STATE OF TENNESSEE
DEPARTMENT OF ENVIRONMENT AND CONSERVATION
 Division of Remediation - Oak Ridge
 761 Emory Valley Road
 Oak Ridge, Tennessee 37830

TDEC Approval Letter

Phase 1 Field Sampling Plan for the Proposed Environmental Management Disposal Facility for Comprehensive Environmental Response, Compensation, and Liability Act Oak Ridge Reservation Waste Disposal, Oak Ridge, Tennessee DOE/OR/01-2739&D2, April 2018

To Expedite Groundwater Characterization
Central Bear Creek Valley Site 7c

Attachment

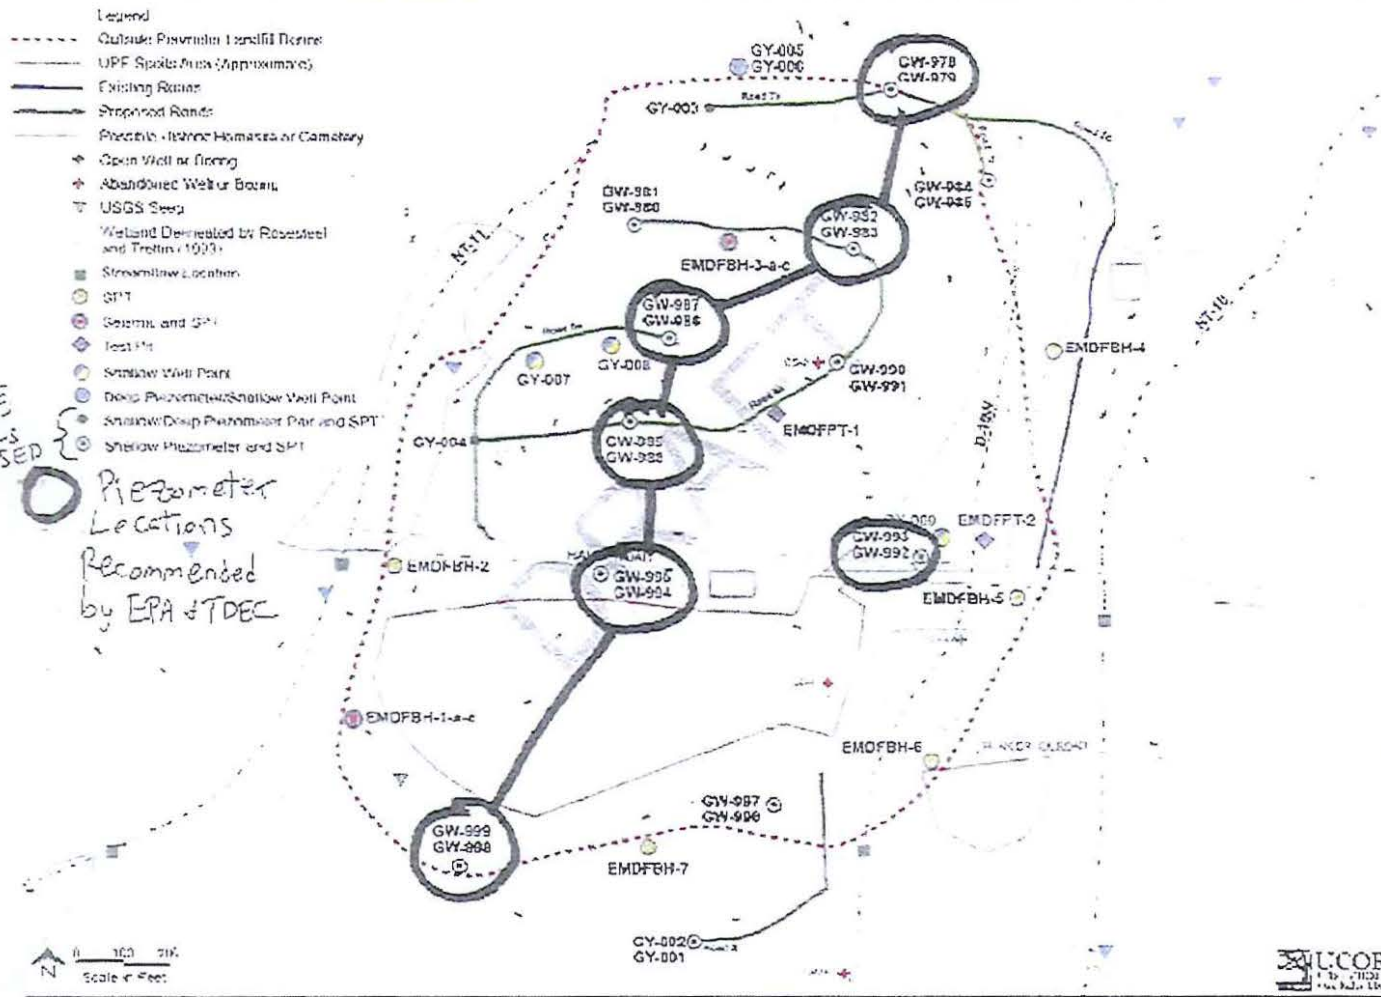
based on data quality objectives that DOE scoped collaboratively with EPA and TDEC. TDEC annotated the attached copy of the map to illustrate the groundwater SOW described herein.

At a minimum DOE must collect the data described above from seven (7) of the approximately 24 locations planned as illustrated on the attached July 20th map. These locations are listed below from the uphill end of the proposed site to the downhill end.

Piezometers	Rationale	Comment
GW-978/ GW-979	Upgradient edge of site in saddle that partially separates the site from Pine Ridge	Edge of proposed perimeter berm
GW-982/ GW-983	Atop a knob (hill) that may have high groundwater levels, per the D5 RI/FS report	D5 Figure 7-1 indicates the pre-construction water table may intersect the facility
GW-986/ GW-987	Within a valley that partially bisects the knob within the heart of the site	
GW-988/ GW-989	Atop the knob that may have high groundwater levels, as suggested in the D5 RI/FS report	Setting is similar to GW-982/GW-983, but this location is further away from Pine Ridge
GW-994/ GW-995	At downhill end of the knob within the heart of the site	
GW-998/ GW-999	Near the downhill end of the site	Map suggests this location lies within the Nolichucky Shale less than 100 feet from its contact with the karstic Maynardville Limestone
GW-992/ GW-993	Along stream D-10W where field observations suggest potential groundwater discharge	Off the cross-section near D-10W

The July 20th map (attached) does not identify the boundary of the buffer zone required for monitoring and potential future corrective action. DOE must estimate the buffer zone boundary which shall not overlie the karstic Maynardville Limestone or its contact with the Nolichucky Shale². DOE shall measure the flow of surface water using standard flumes or weirs where any stream (e.g., NT-10, D-10W, and NT-11) enters and leaves the buffer zone. For streams originating within the site/buffer area, spring discharge or stream flow shall be measured as close as possible to the spring/seep zone. In order to measure the entire flow, each device must be constructed deep enough in the channel to minimize the flow of water under or around it. The downstream locations must be on the Nolichucky Shale, not the Maynardville Limestone. DOE shall instrument each stream gaging station to record discharge (flow), temperature, conductivity, and pH at intervals of at least every 30 minutes.
